Sequoyah Nuclear Plant

Steam Generator Replacement Project Topical Meeting

TVA/NRC Meeting

October 24, 2002

Figure 1 – Steam Generator Haul Route

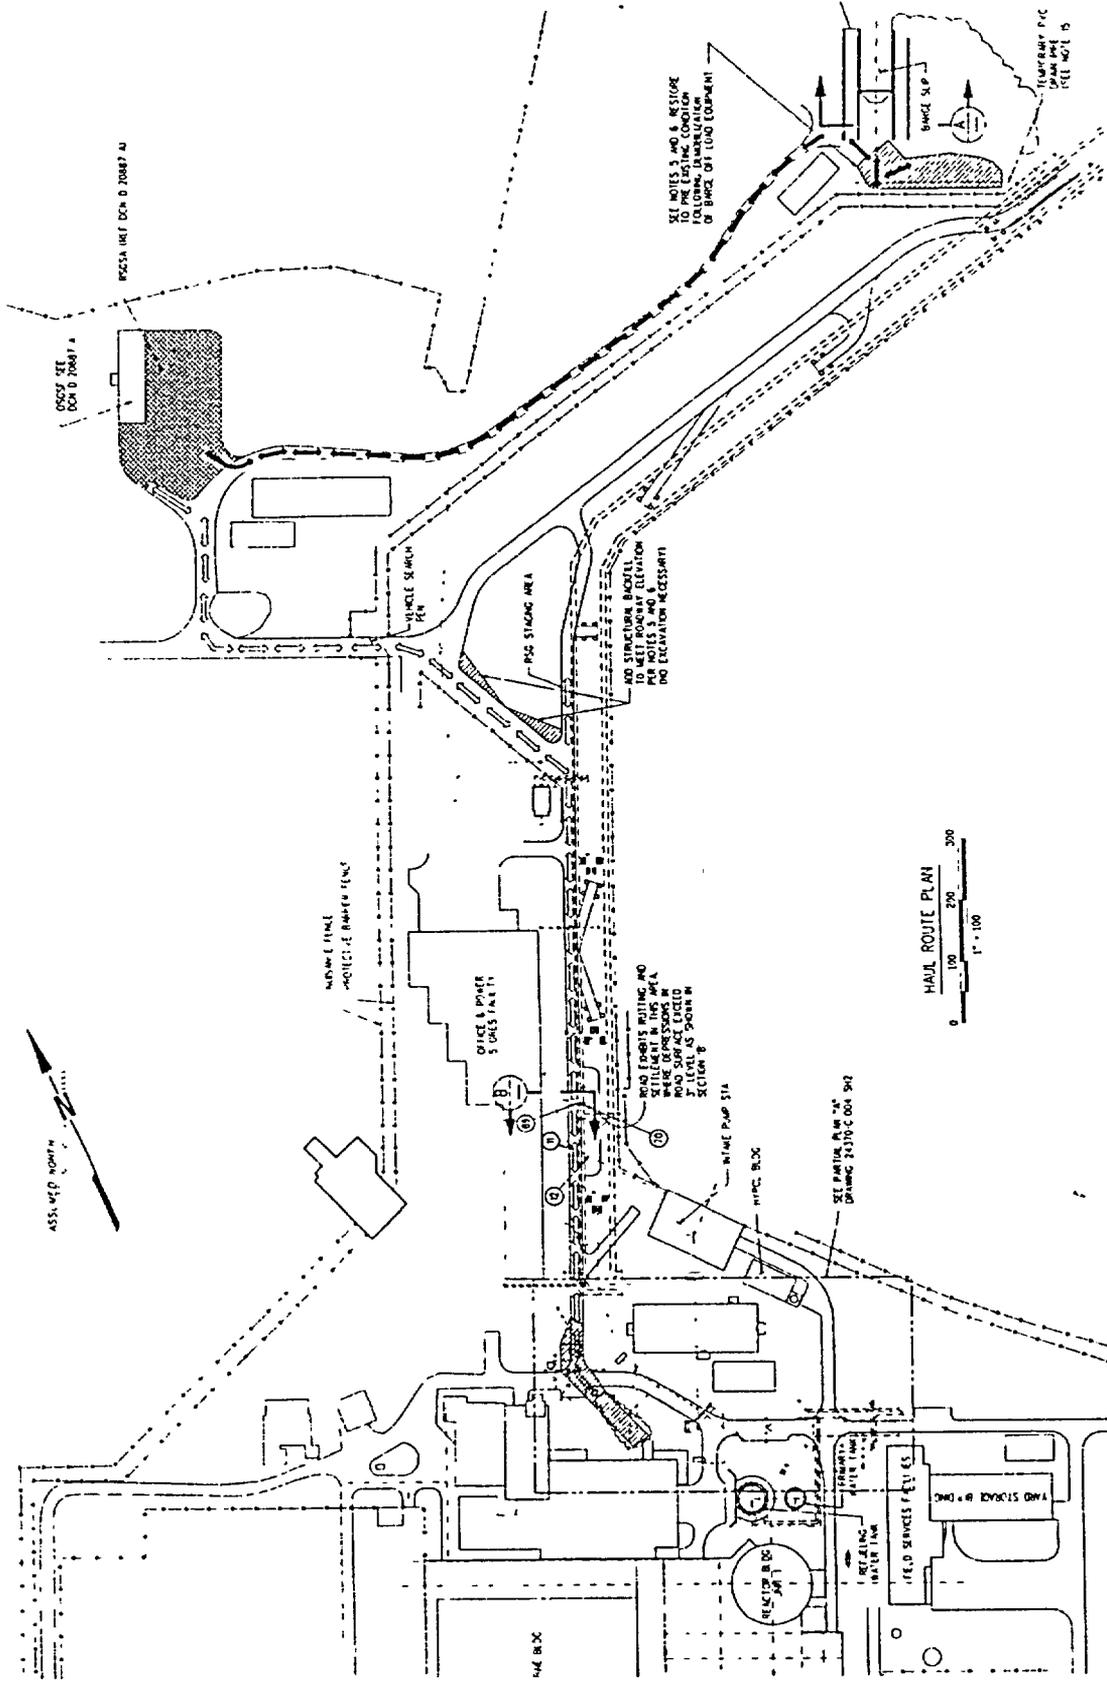
8. The topical report discusses the dose consequences of dropping an original steam generator outside the containment. For staff to complete review of your dose consequences analysis, additional information is needed on the referenced calculation (Reference 23 of the topical). Provide the assumptions, inputs and methodologies used to determine the dose consequences of dropping the original steam generator. This should include the source term (isotopes and activities), control room ventilation system operation assumptions and the atmospheric dispersion factors (X/Qs) used in the dose calculation. Additionally, if the X/Qs are newly calculated and have not been reviewed by the staff, provide the inputs (including meteorological data), assumptions (including the location of the drop) and methodologies used to calculate the X/Q values.

20. The topical report provides no information on the haul route from the transport location identified on figure 5-2 and whether the potential to interact with safety-related SSCs exists along the haul route, and whether those SSCs could either withstand the impact of a dropped SG or will be protected to preclude them from damage. What is the distance between the lay down area and the old and new SG storage area and what is the method used to load test the haul route (civil/structural)? What are the safety-related components that are located along the haul route that could be impacted by a dropped SG? What safety functions/systems would be impacted? What measures are to be taken to preclude a SG drop along the haul route and preclude the identified components from being damaged if a SG drop occurred?

The calculation performed to estimate worst-case atmospheric dispersion factors (X/Qs) at the EAB and at the LPZ for a hypothetical steam generator drop accident occurring at any point along the steam generator haul route [Figure 1] during the SGR is summarized below.

3. The containment building cross-sectional area (1800 m²) used in estimating the atmospheric dispersion factors were as reported in UFSAR Section 2.3.5.2.
4. A haul route drawing [Figure 1] shows the locations of the steam generator haul route and the old steam generator storage facility (OSGSF).
5. The elevation at the top of the containment building is 856.04 ft with a grade elevation of 705 ft. Therefore, the physical height above ground level of the containment building is 151 ft (46 m).

The steam generator (SG) haul route is shown on Figure 1 in the response to Question 8. The distance from the downending/upending (lay down) area to the old steam generator storage facility (OSGSF)/replacement steam generator storage area (RSGSA) is approximately 2,180 ft. A review of structures, systems, or components (SSCs) in the vicinity of this portion of the haul route determined that the only safety-related SSCs are the ERCW ductbanks, manhole (MH) groups 31 and 32, handhole (HH) group 52, and 36 inch diameter ERCW piping. The manhole and handhole groups are associated with the ERCW ductbanks. There are no safety-related utilities close enough to the portion of the haul route between the replacement steam generator (RSG) barge offload area and the RSGSA to be affected by a load drop.

Figure 7-3 – Finite Element Model "SGE1" and "SGE2" and Element Groups and Global Coordinate Systems (Reference 6)

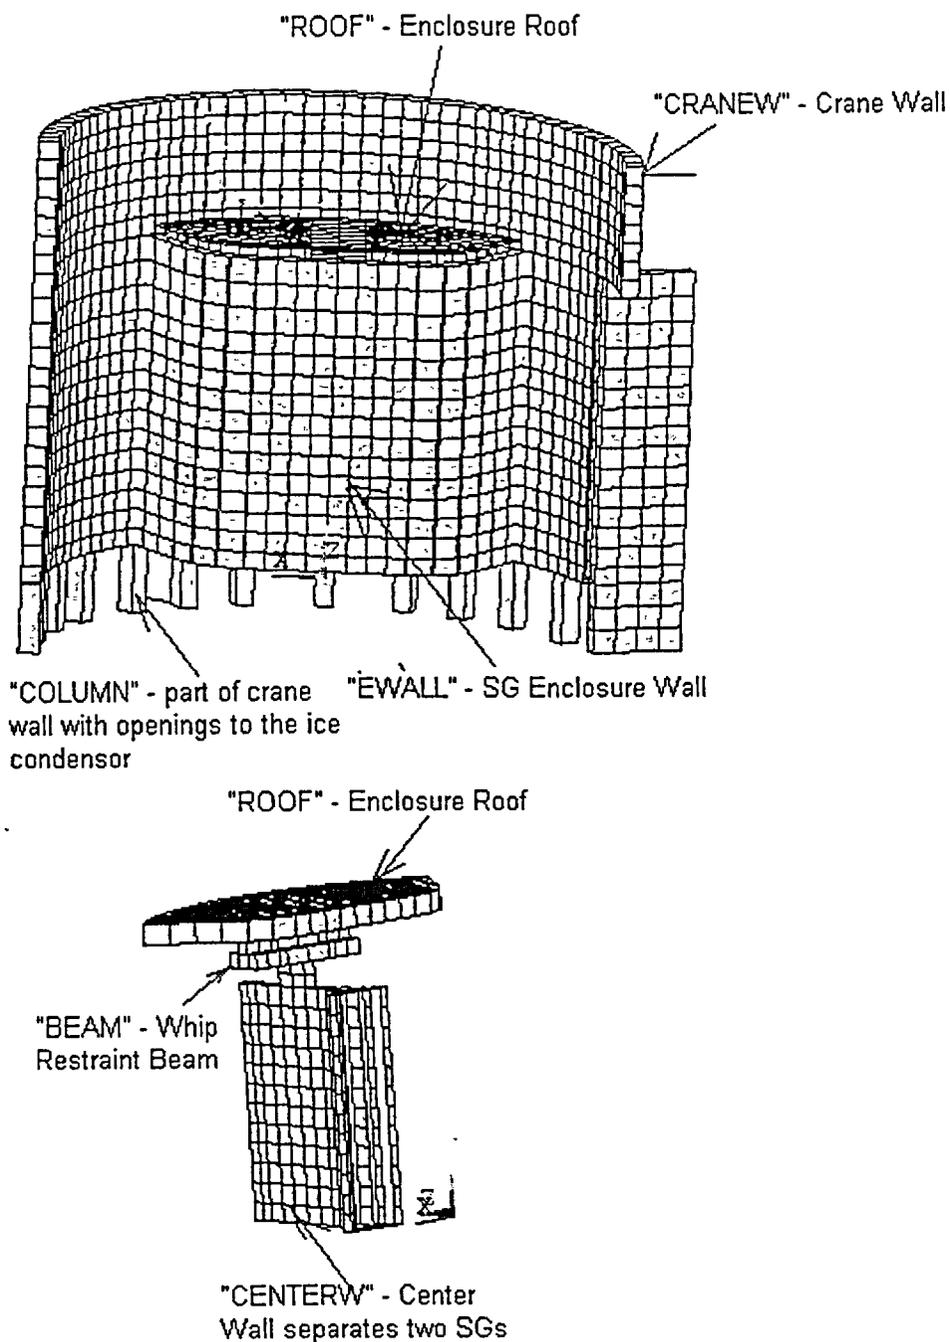
39. On page 27 the report states that "[t]he nodes at the cut-line along which the splice-plate connections are located were realistically modeled to transmit vertical forces and in-plane compression only." Was a zero force assumed in the vertical direction to be taken by the grout? If not, provide the justification on the amount of force in the vertical direction to be attributed to the grout.

As stated in the report and discussed in response to Question 34 above, the nodes along the cut-line are modeled to transmit vertical forces and compression only. The grout is not considered to resist any forces other than compression so that there is zero shear force resisted by the grout.
